ARCHITECTURAL REVIEW COMMISSION AGENDA REPORT

SUBJECT: Continued design review of three shell buildings (including a caretaker quarters) totaling approximately 23,397 square feet, with associated site improvements and identified tree removals, with a determination that the project is consistent with the previously-adopted Mitigated Negative Declaration.

PROJECT ADDRESS: 279 Bridge Street

FILE NUMBER: ARCH-4242-2016

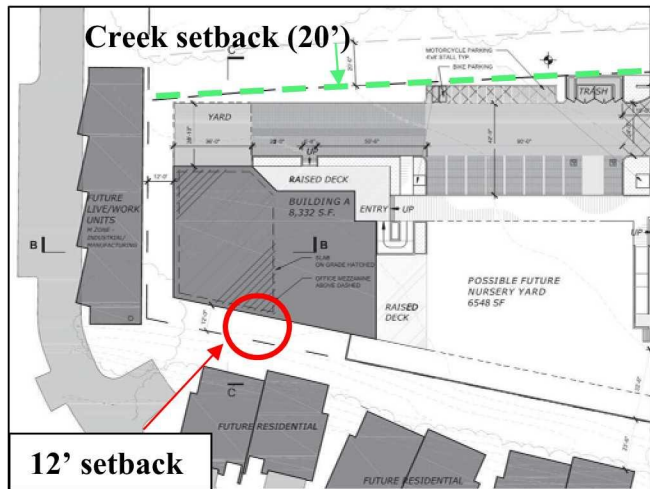
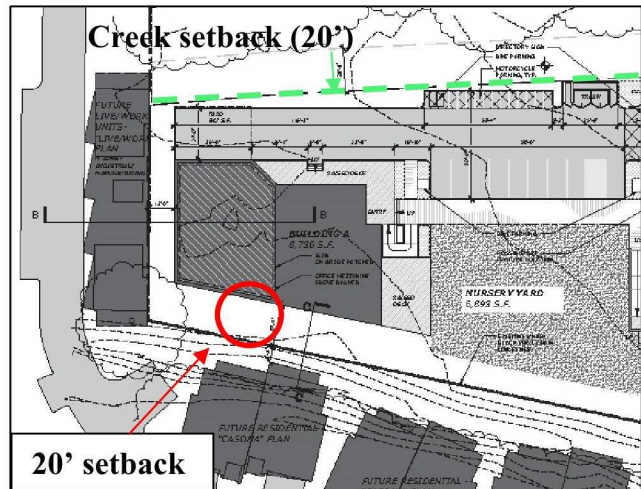
Directional Item #1: Relocate Building A to be further from adjacent residential uses in order to preserve views from the 215 Bridge Street project and providing additional buffering from the proposed commercial building.

Response: The proposed location of Building A has been shifted eight feet to the north, increasing the building setback from the southern property line from 12 to 20 feet (refer to Figures 1 and 2, below). A planted bioswale and a variety of trees including coast live oak, California sycamore, and desert willow are proposed to be planted between Building A and the western and southern property lines (Attachment 3, Re-submitted Project Plans, Sheet L1). Additional discussion regarding site design and neighborhood compatibility is provided in Section 3.2 Public Comments, of this report.

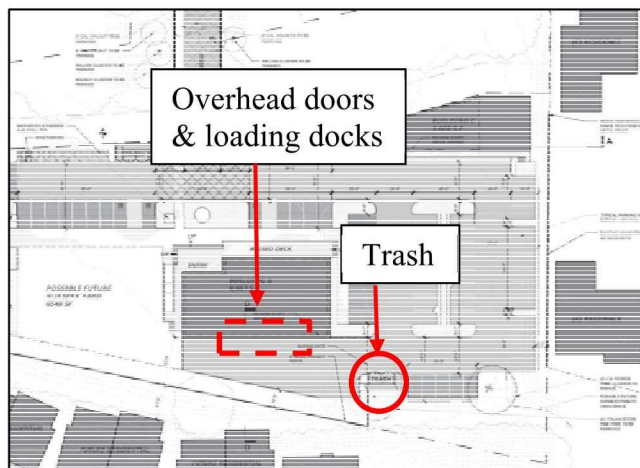
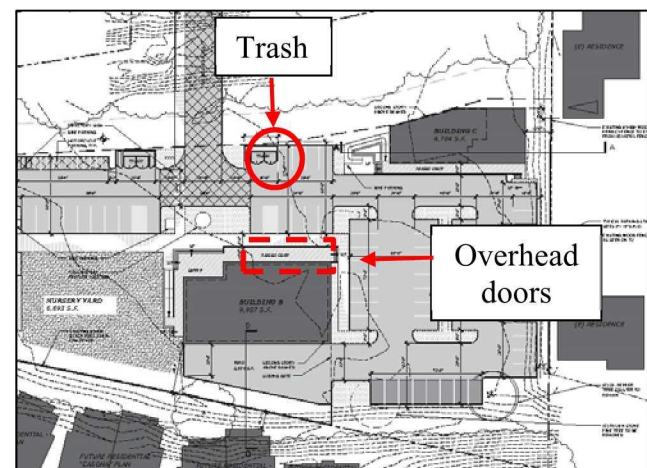
Directional Item #2: Relocate loading docks and trash enclosures as far away as possible from adjacent residential uses. Loading docks should be provided on the north side of the proposed buildings or between clustered buildings to buffer noise from adjacent residential uses.

Response: The overhead doors and loading docks on the south side of Building B (see Figure 3) have been relocated to the north side of the building, facing away from the adjacent residential uses (see Figure 4). Trash enclosures have been relocated from the southern portion of the property, as shown in Figure 3, to the center of the property, north of Building B (refer to Figure 4). The Building A loading dock and overhead door remain on the north side of the building, in
